STATE OF MAINE  
DEPARTMENT OF TRANSPORTATION  
16 STATE HOUSE STATION  
AUGUSTA, MAINE  
04333-0016

June 20, 2008  
Subject: **Madrid**  
State Project No. 010019.00  
**Amendment No. 3**

**Madrid**  
**PIN 10019.00**  
**Route 4**  
**Highway Reconstruction**  
**June 16, 2008**

TYPICAL SECTIONS

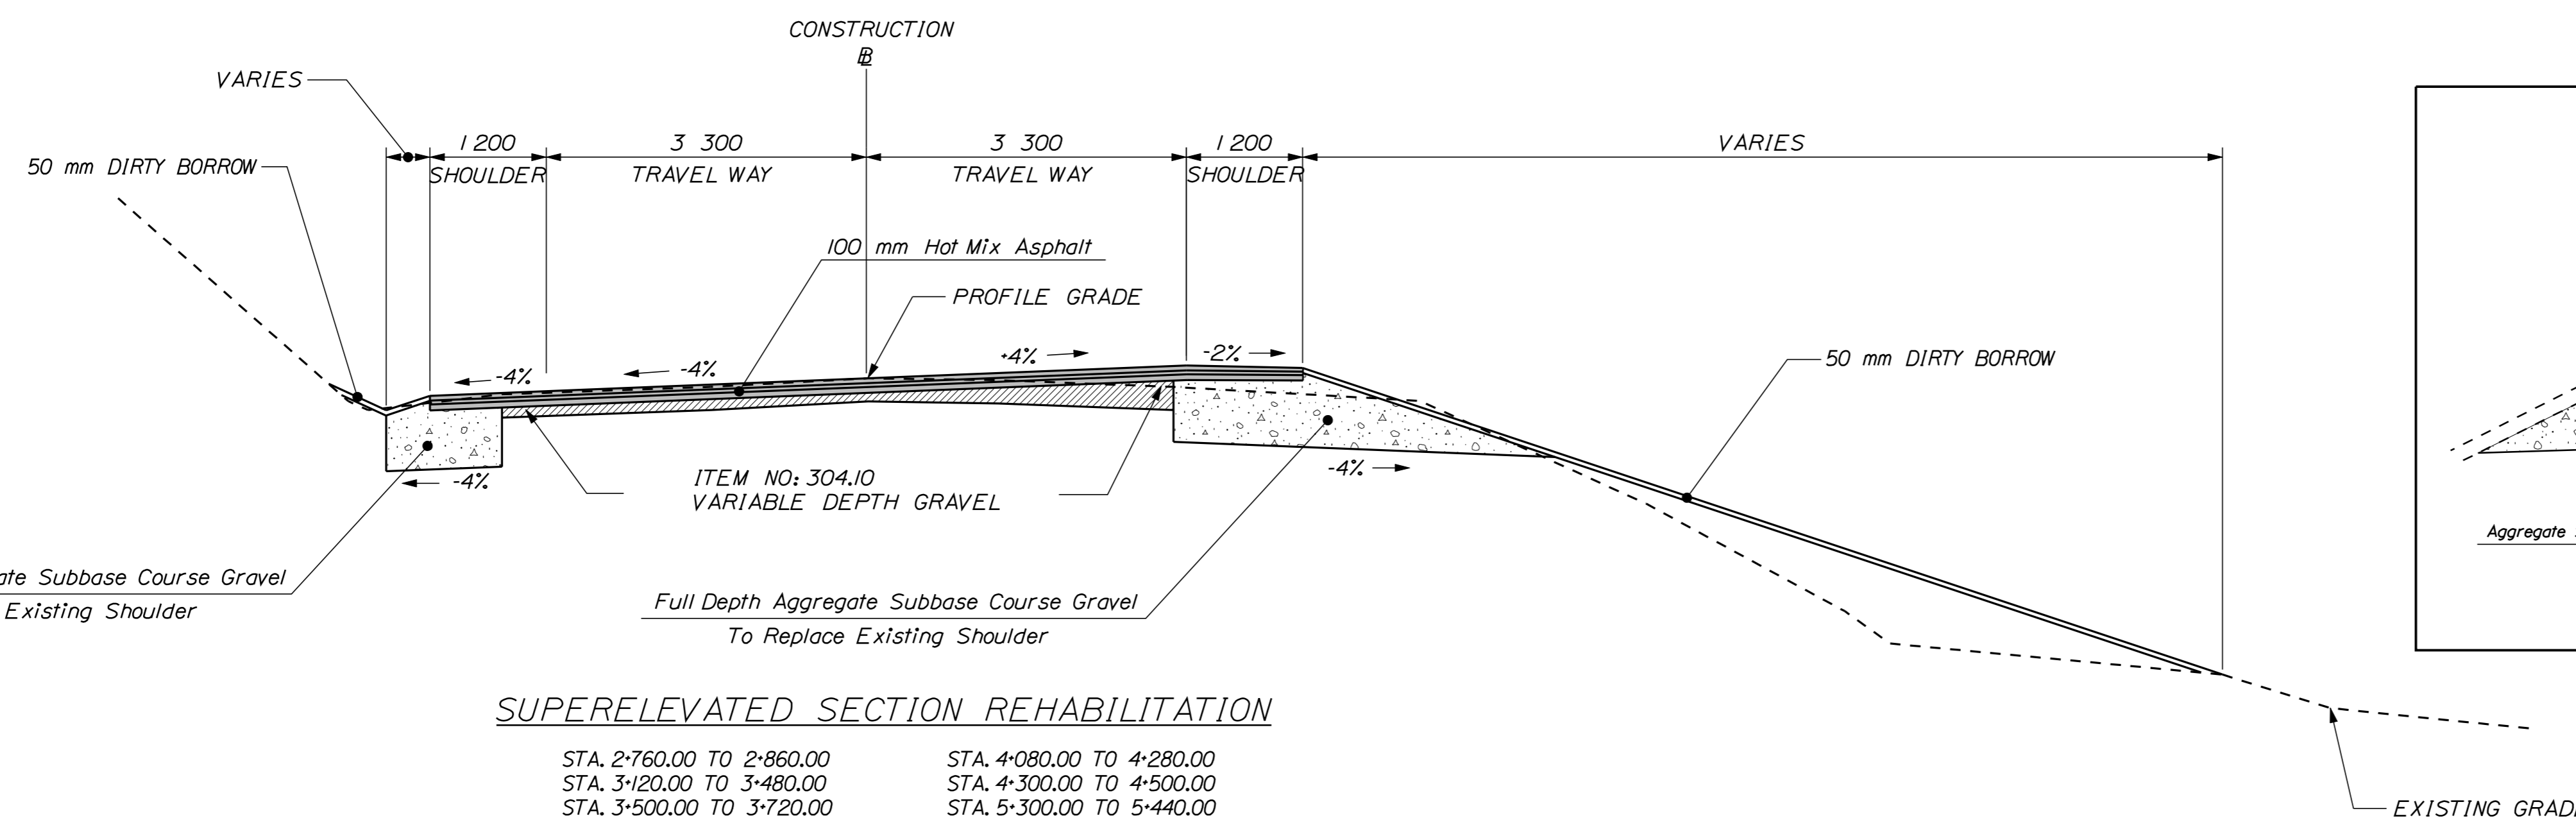
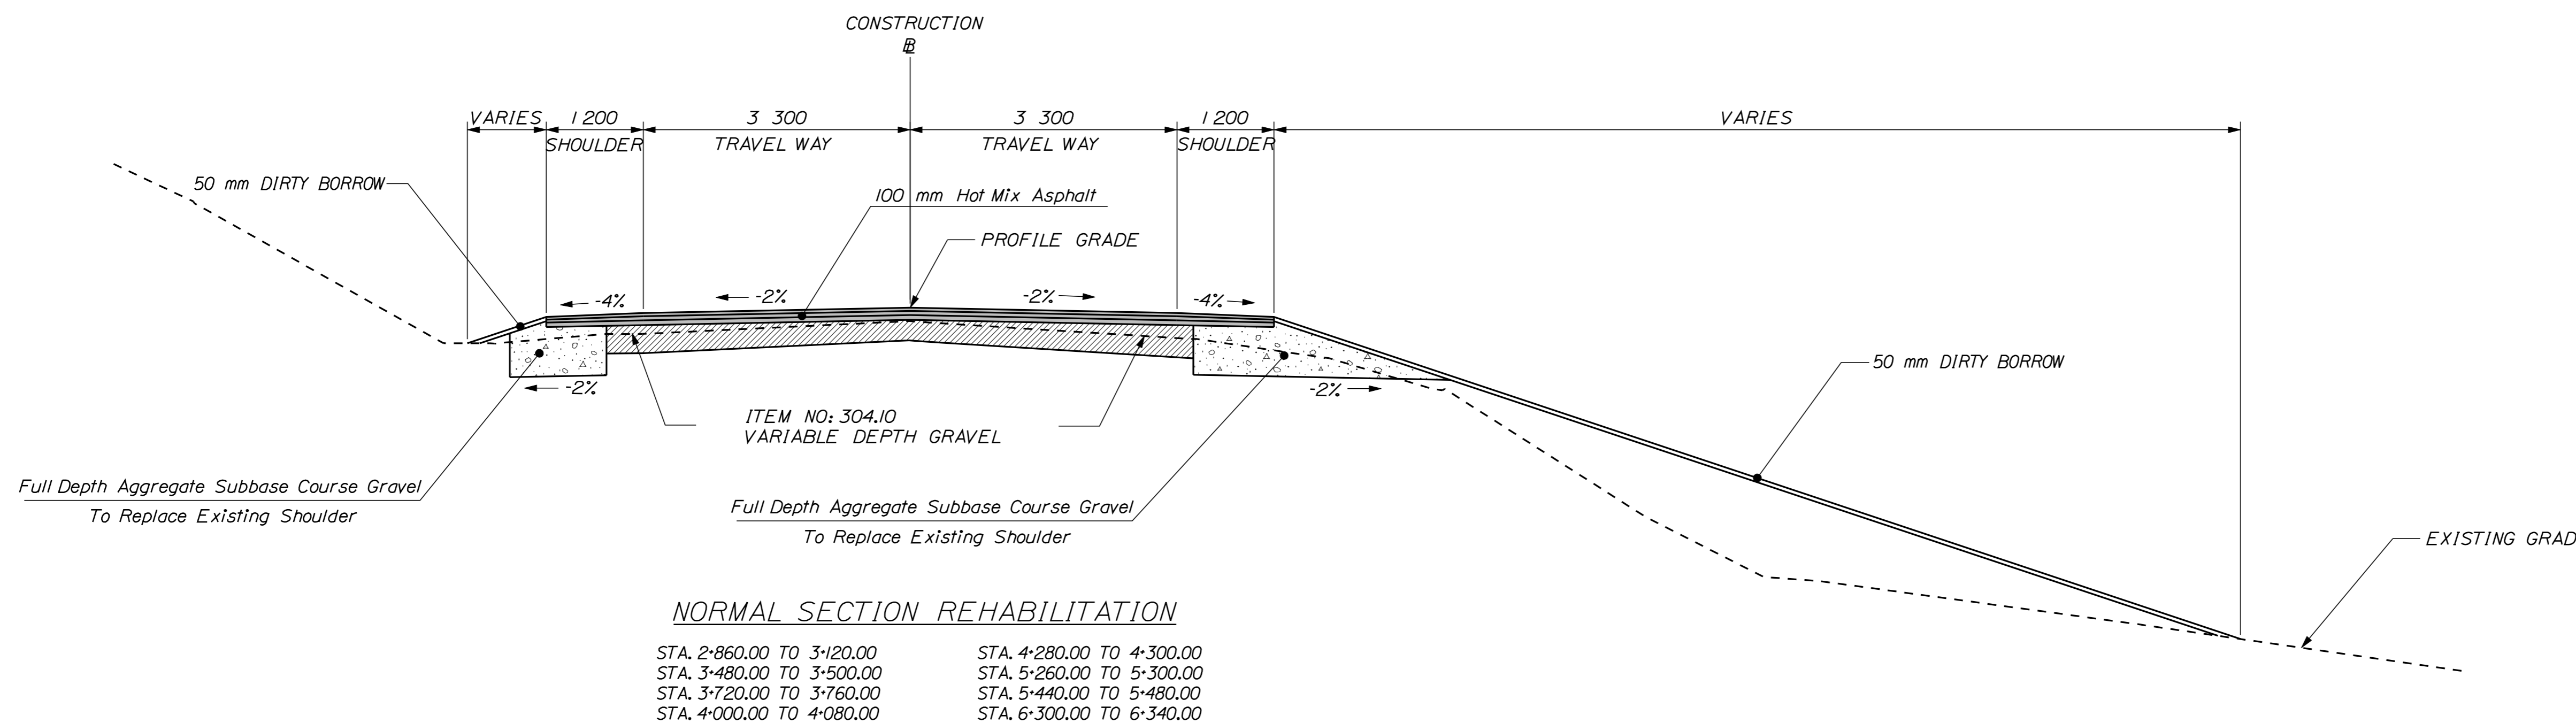
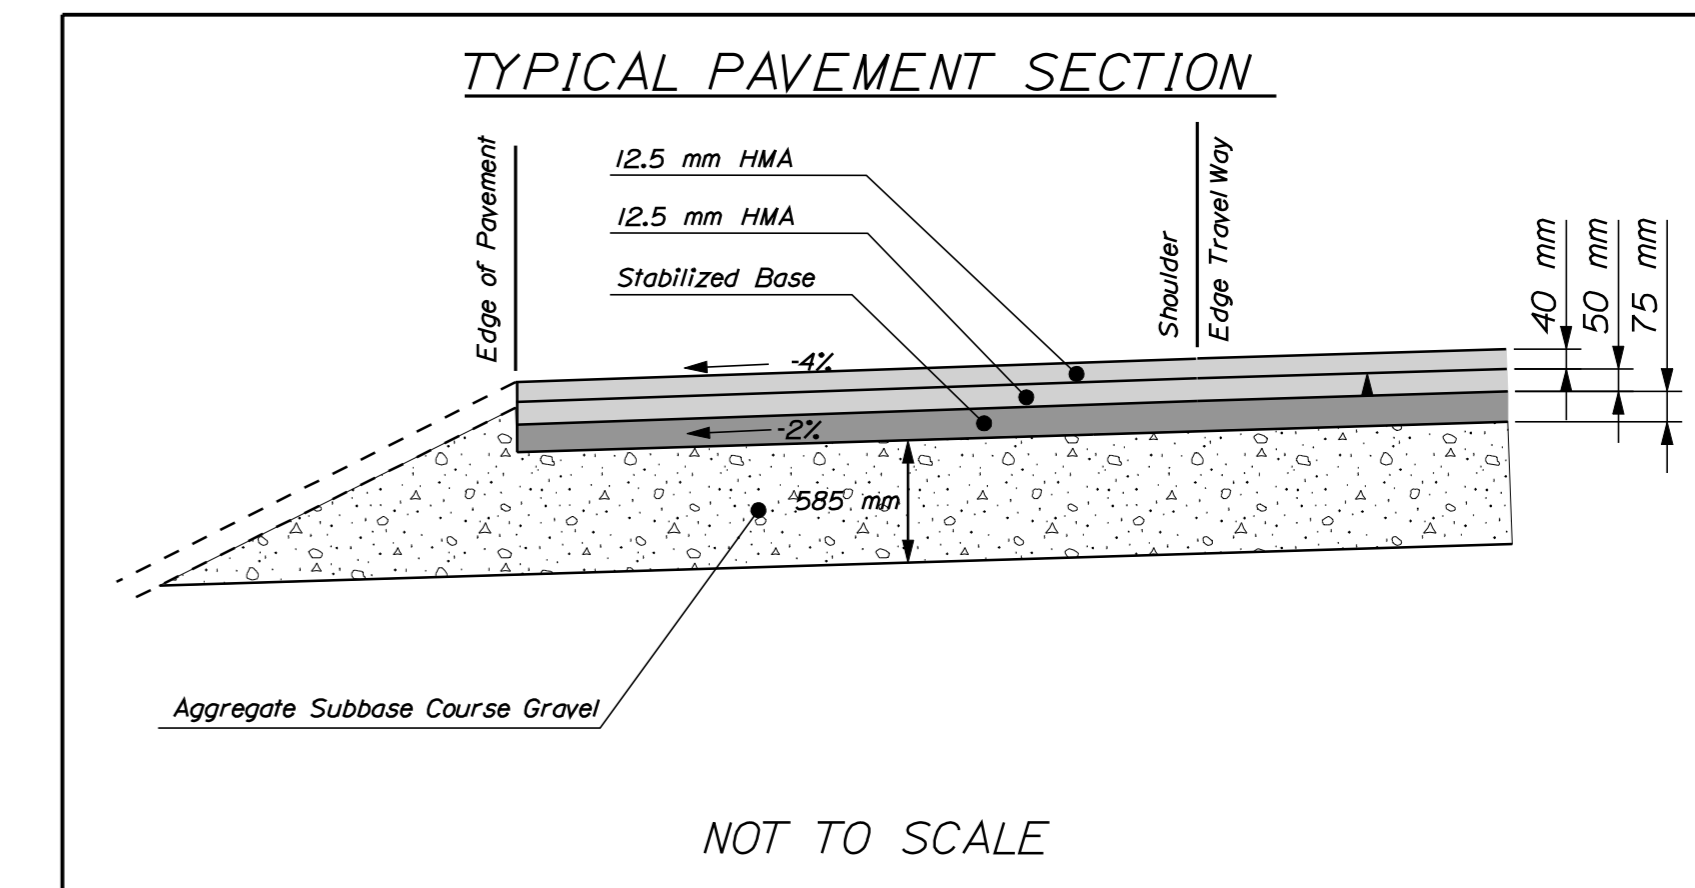
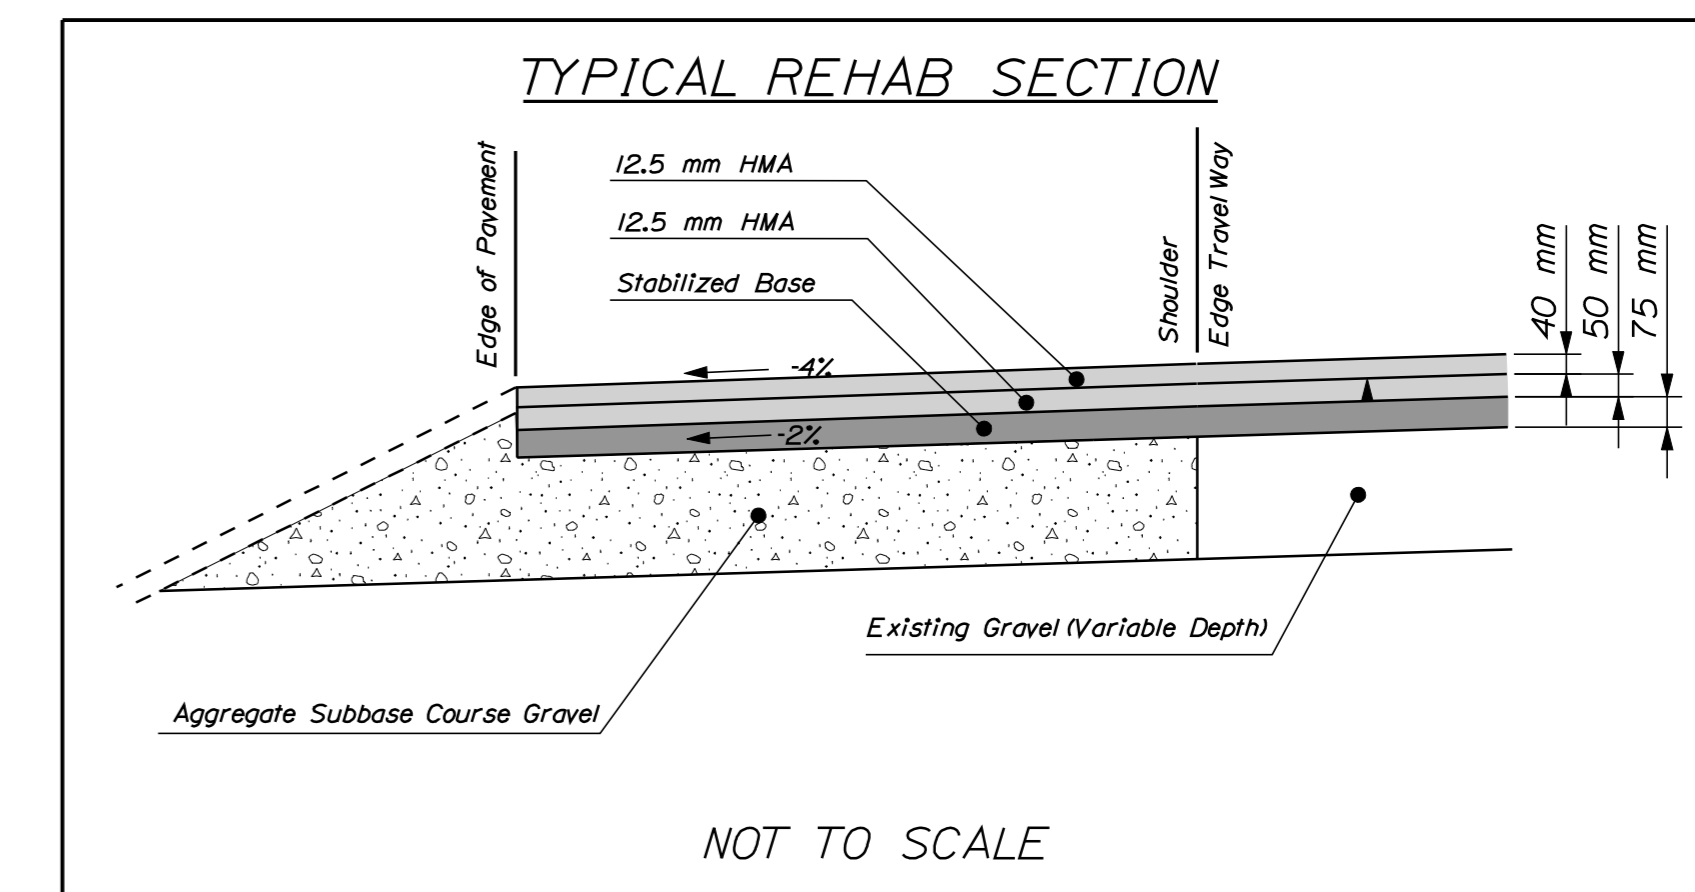
In the Plans, TYPICAL SECTIONS, **REMOVE SHEET 1 OF 3** and **REPLACE** with the attached (and mailed or FEDEXED) new TYPICAL SECTIONS, SHEET 1 OF 3. (Plan changes will be FEDEXED to street address and mailed to PO Boxes.)
